Swan soundbar

Speaker cable drawings for control run + Pre-MP + MP(~15K)

ALT Co., Ltd.

Issued Date 2021.08.24

SPEC_4AI20-CMXX04 – Left channel speaker cable drawing

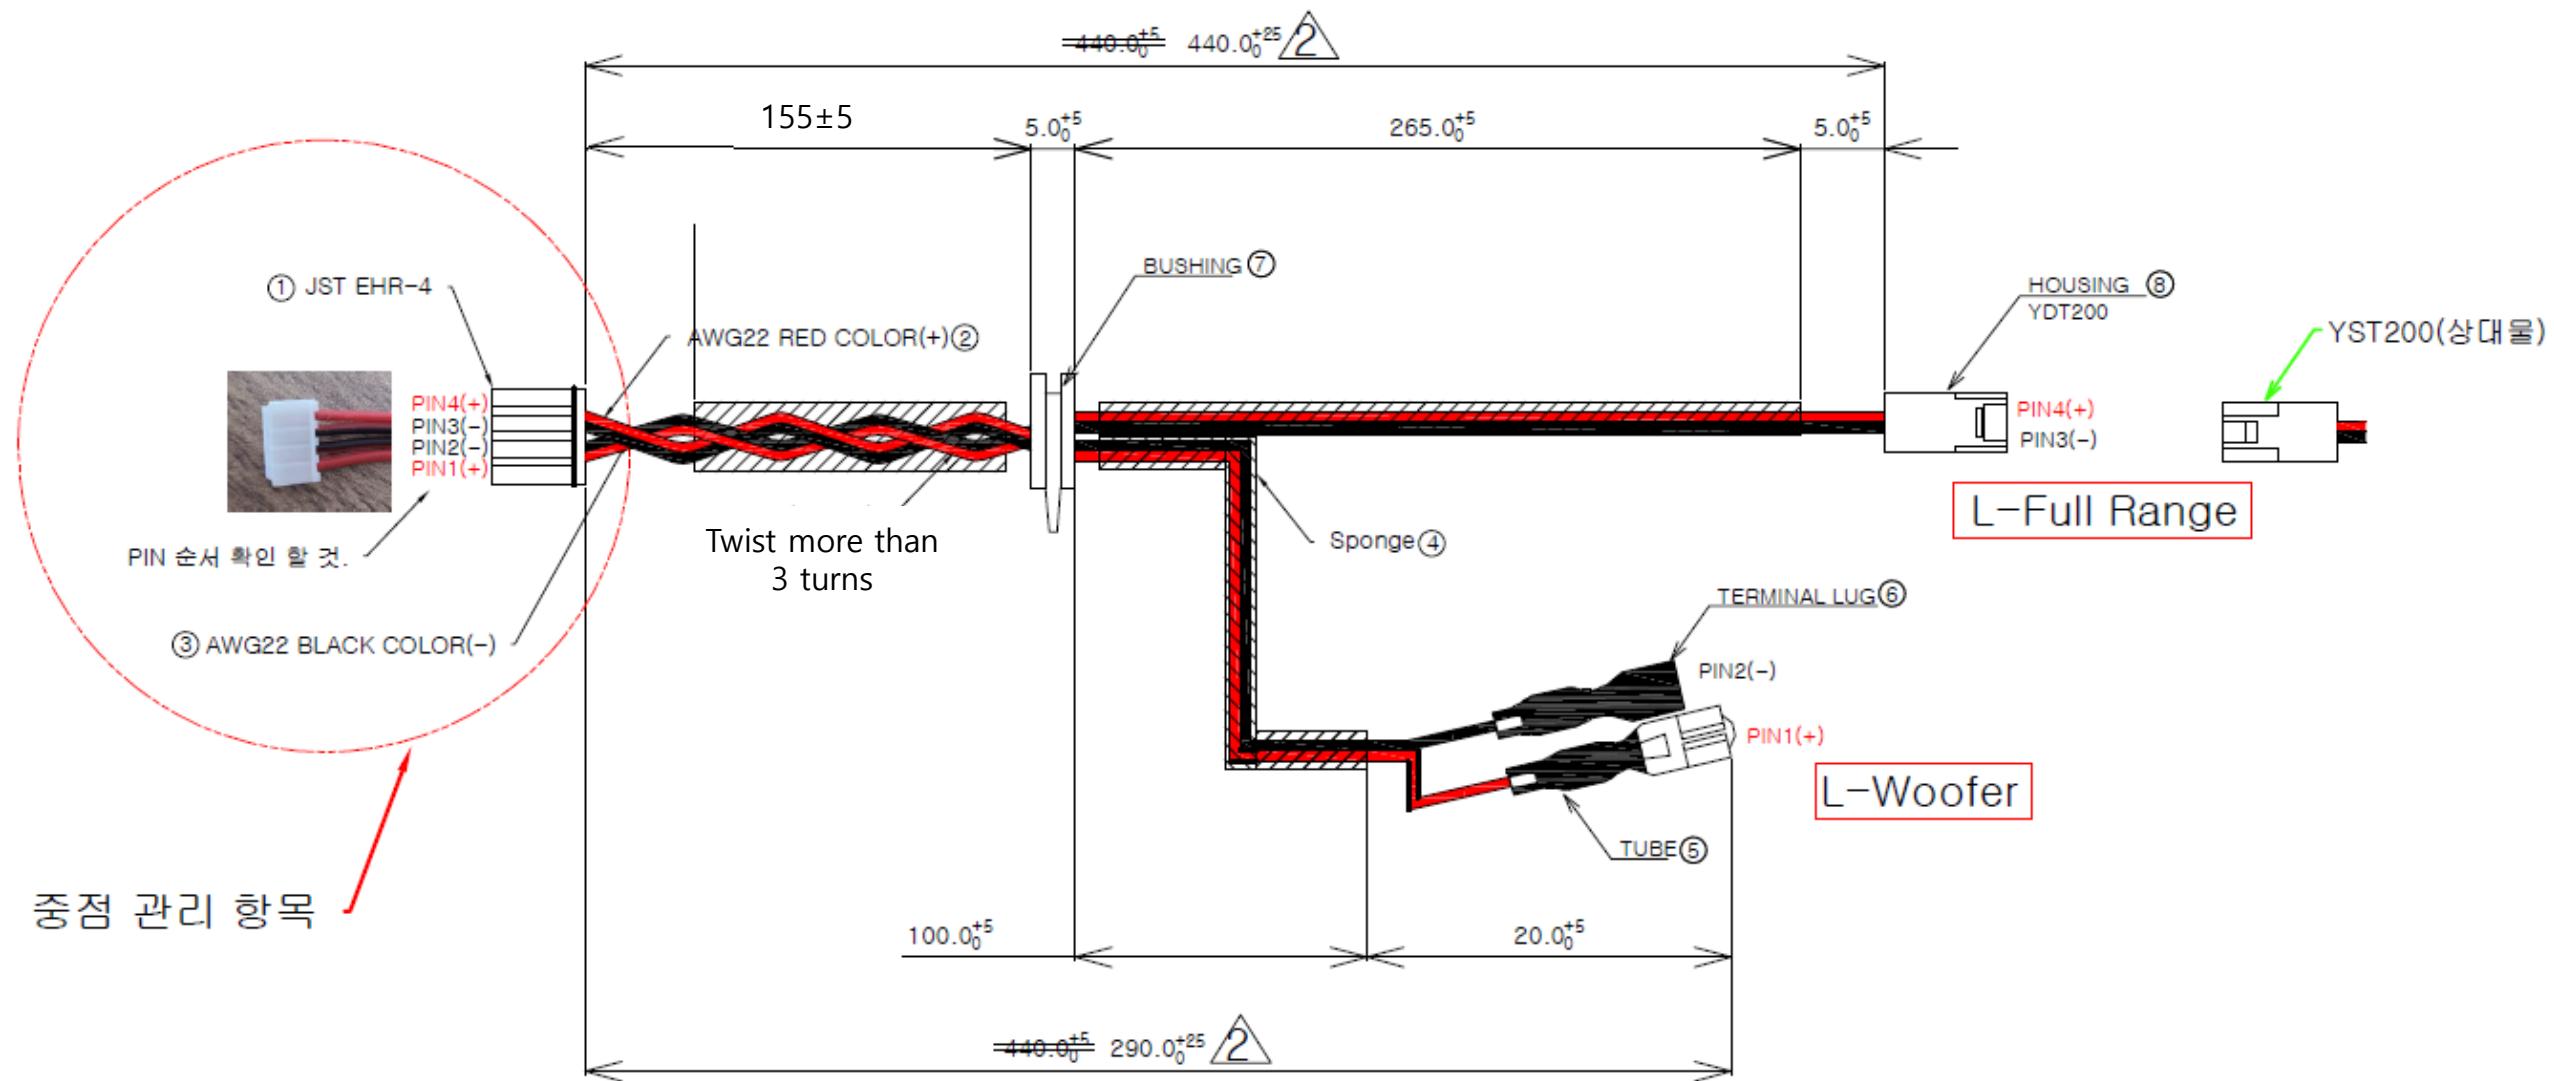
- Due to cable twist **rework by hand**, twist length may vary.
- Rework cable will be supplied up to 15K production.
 - After 15K, will be supplied the drawing dimensions by **machine work**.
- Request to factory
 - Skip the IQC on cable twist spec
 - If the cable length is longer than the guide, please twist more when final assembly
 - Please refer to the guide for next page

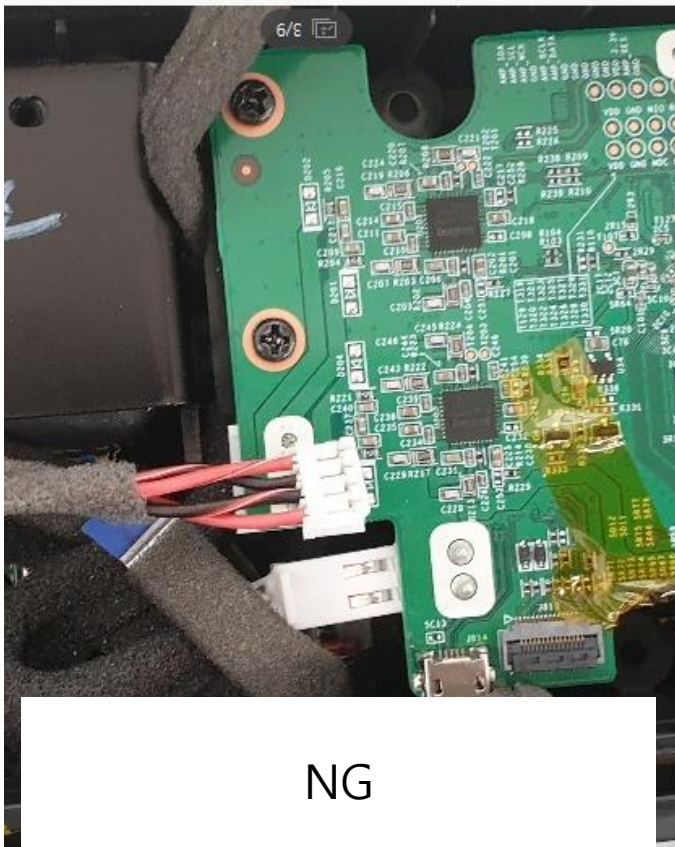
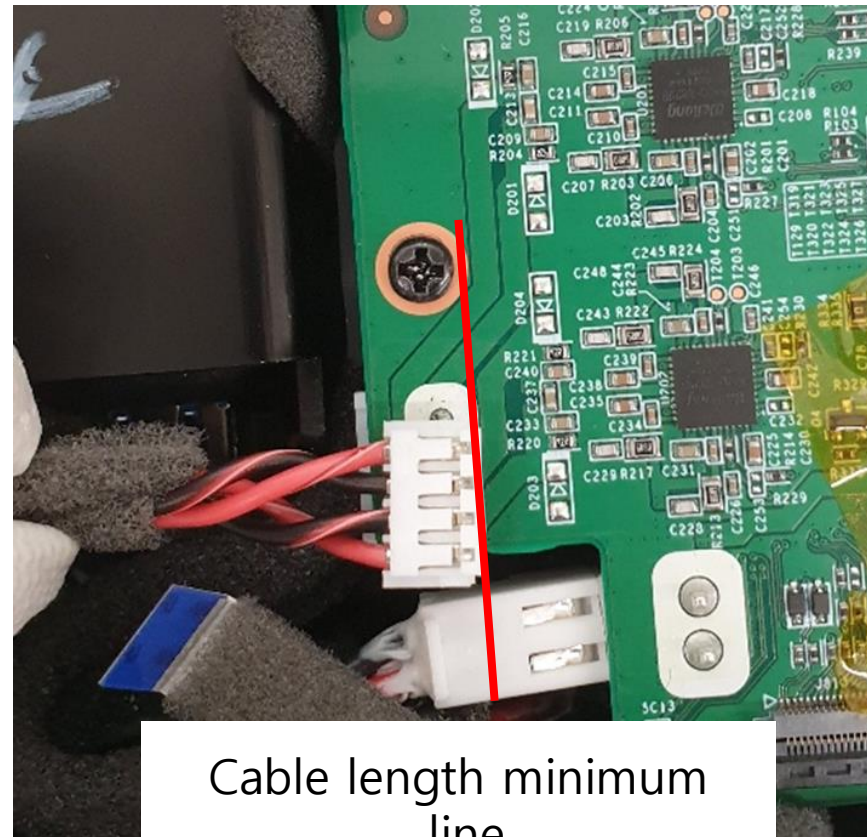
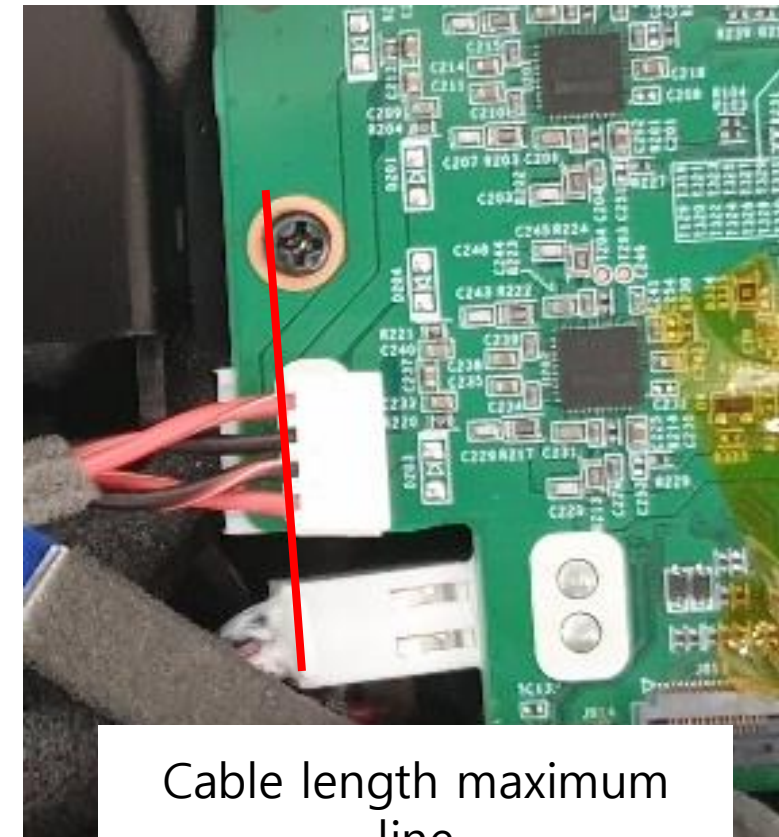
- The speaker connector should be placed on the silk area
 - if the speaker connector is not placed on the silk area, please twist the cable
 - See below min / max cable length example

NG

Cable length minimum
line

Cable length maximum
line
